Product Change Notification

1. ECN #: 243782

- TFM - .050 X .050 MICRO STRIPS
- TFML - .050 SHROUDED TERMINAL

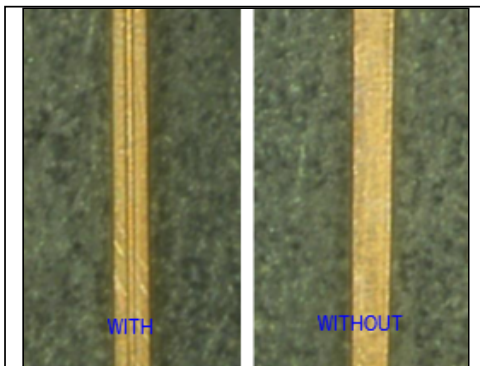
ADDED COINED GROOVE TO ONE SIDE OF TAIL TO AID STRAIGHTNESS

CUSTOMER CAN SEE WHAT APPEARS TO BE A SCRIBE LINE DOWN THE LENGTH OF THE TAIL ON ONE SIDE

ONE SIDE WITH, ONE SIDE WITHOUT

COINED GROOVE KEEPS THE TAIL STRAIGHTER
